REMARKS

The drawings stand objected to under 37 CFR 1.83(a) for not illustrating “the chief ray corresponding to the largest half-field angle” and the “half-field angle of a ray incident onto the image pickup surface”. In response to this objection, the Office Draftsperson has been requested to enter replacement drawing sheets 1 - 8 in lieu of the drawing sheets 1 - 7 as originally filed. The requested changes to the drawing figures are as follows: in Fig. 7(a) the symbols  $wy$  and  $wy'$  have been added in order to illustrate that which was claimed in claim 1 as filed. Also, Fig. 7(c) has been added to show an enlarged view of the lens portion of Fig. 7(a) in order to more clearly indicate the angles  $wy$  and  $wy'$ . The above changes to the drawings are believed to **not** constitute “new matter”, since the symbols  $wy$  and  $wy'$  were described in the disclosure as filed, and Figs. 7(a) and 7(c) merely make clear in the replacement drawings that which was adequately described in the disclosure as filed.

Fig. 7(a)

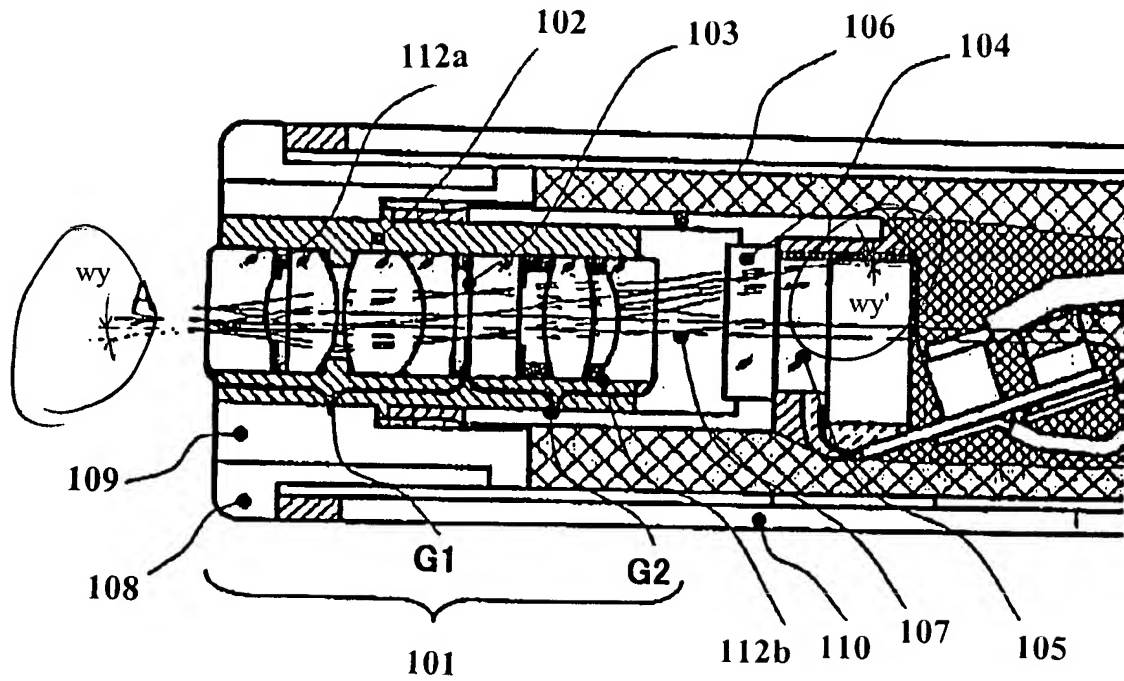
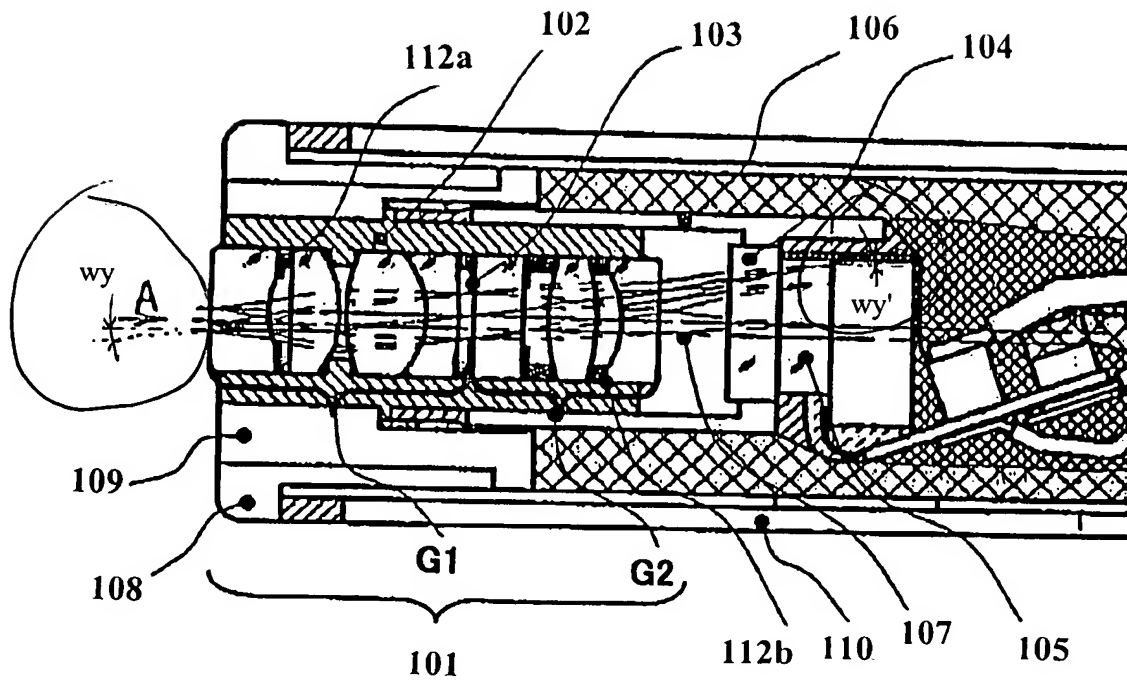
Claims 1 and 7 stand rejected under 35 U.S.C. 112, first paragraph, as failing to comply with the written description requirement, on the basis that claims 1 and 7 contain subject matter which was not described in the specification in such a way as to reasonably convey to one skilled in the relevant art that applicant had possession of the claimed invention. More specifically, the Examiner states that the angle  $wy'$  (which is described in the disclosure as filed as being “the angle at which the chief ray corresponding to the largest half-field angle is incident onto the image pickup surface”) and the angle  $wy$  (which is described in the disclosure as filed as being “the half-field angle of a ray incident onto the image pickup surface”) are not adequately described in the disclosure as filed. Reconsideration of this rejection is respectfully requested. From viewing Figs. 7(a) and 7(c) of the replacement drawing sheets, it is respectfully submitted

(1) clarified in the drawings how the angles  $wy$  and  $wy'$  are measured, without adding new matter,

Fig. 7(c)

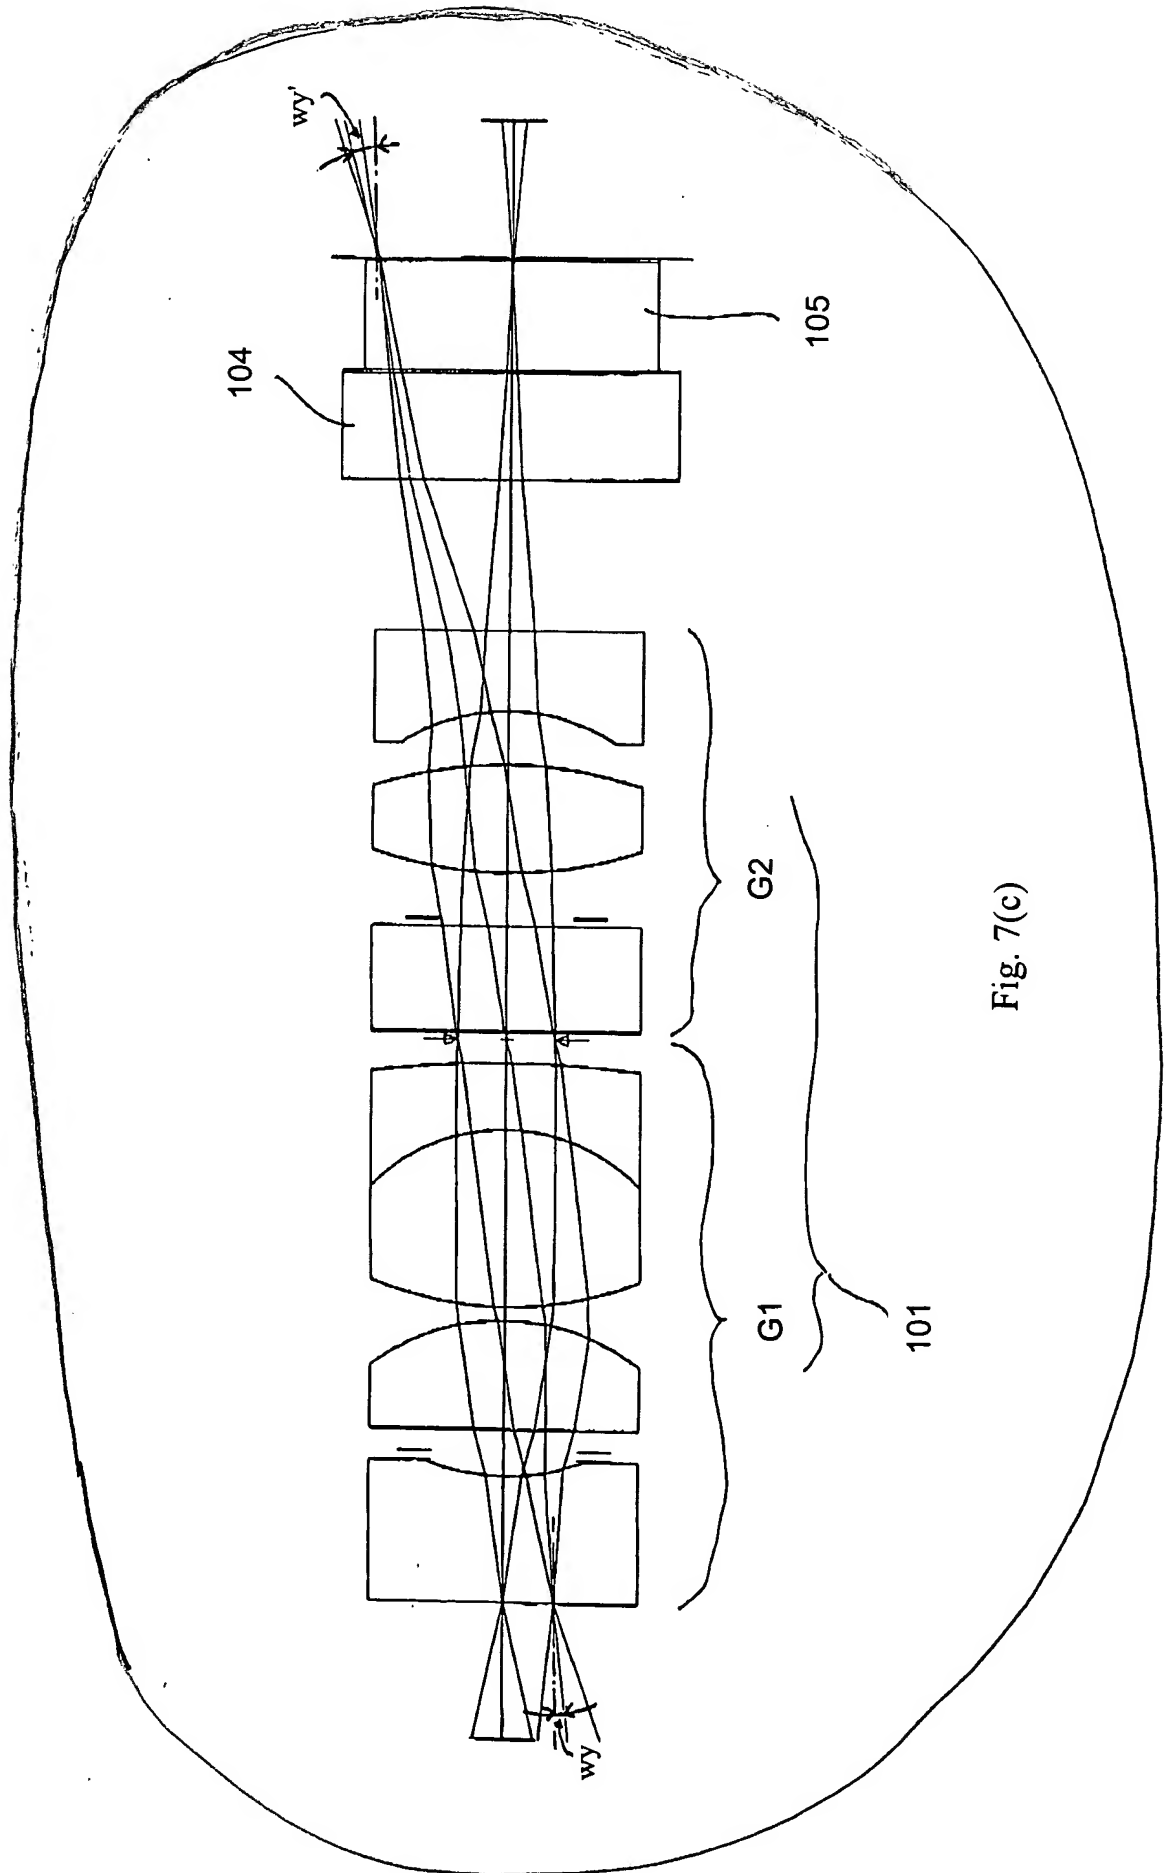
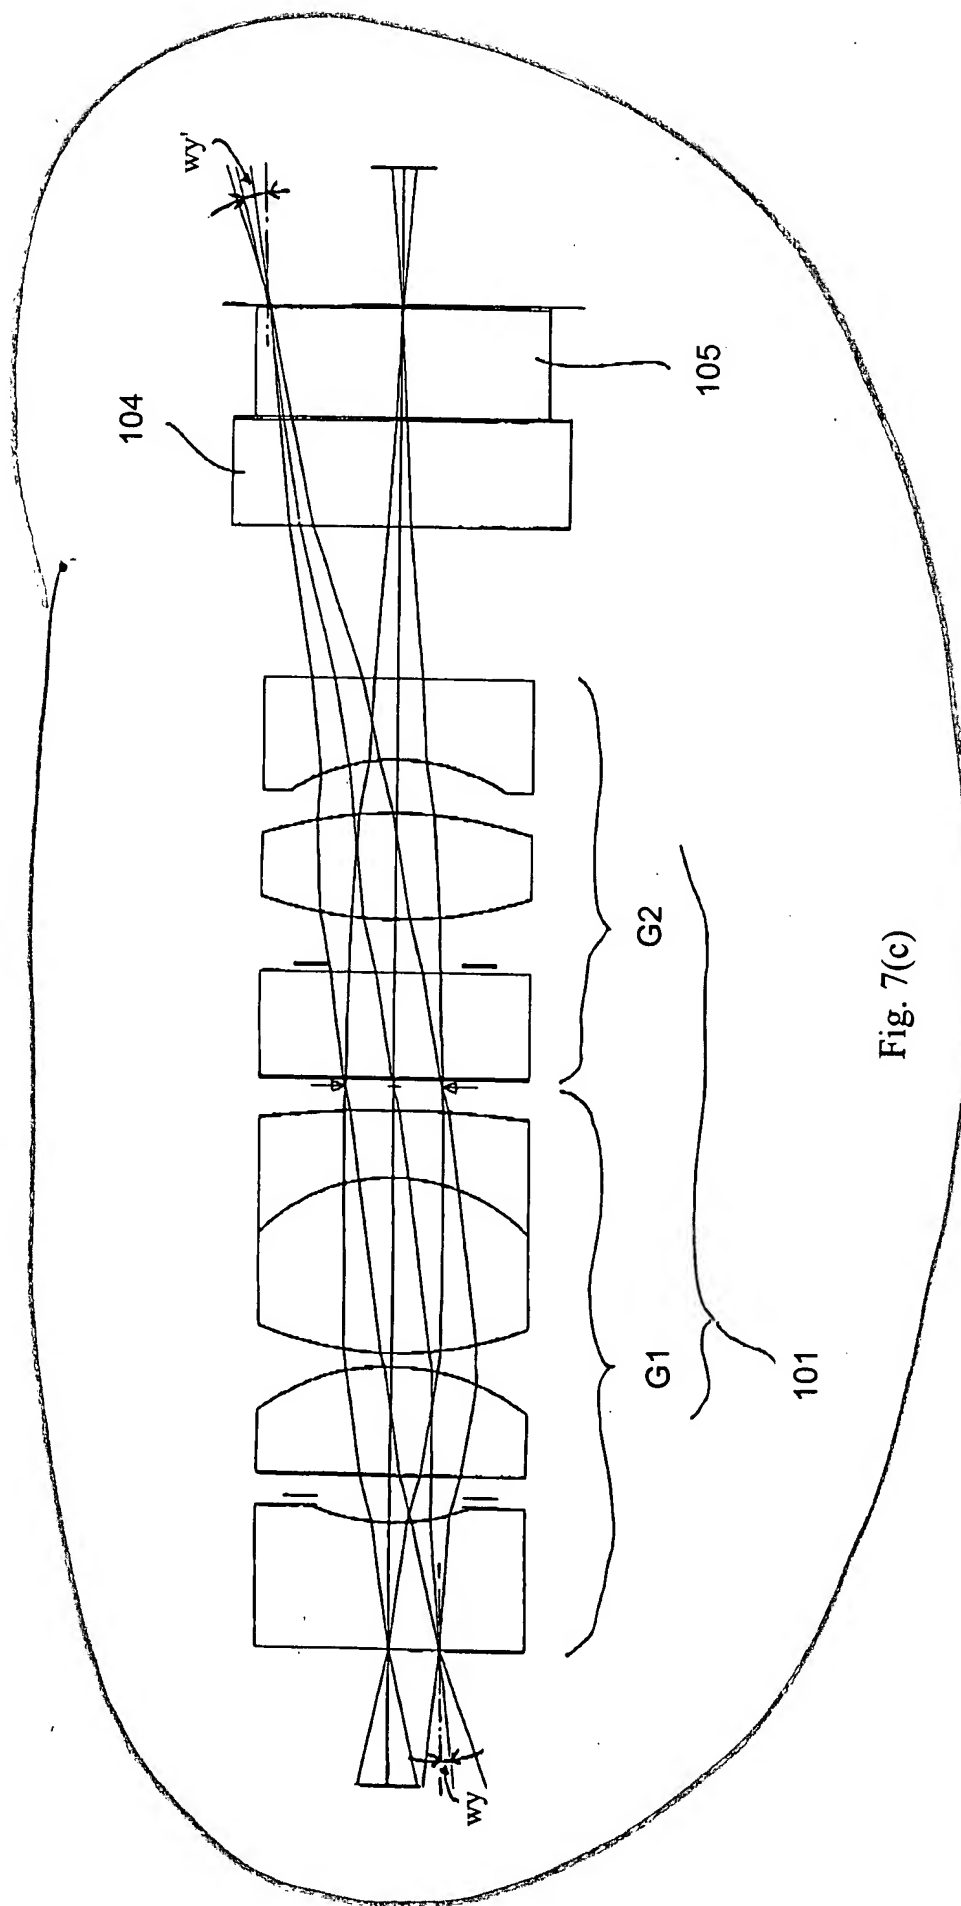
The specification has been amended above at page 6 so as to refer to Figs. 7(a) - 7(c) in lieu of the description in the specification as filed that referred to Figs. 7(a) and 7(b). Also, Table 3 has been amended to refer to the ‘chief ray’ rather than to the - - main ray - - .
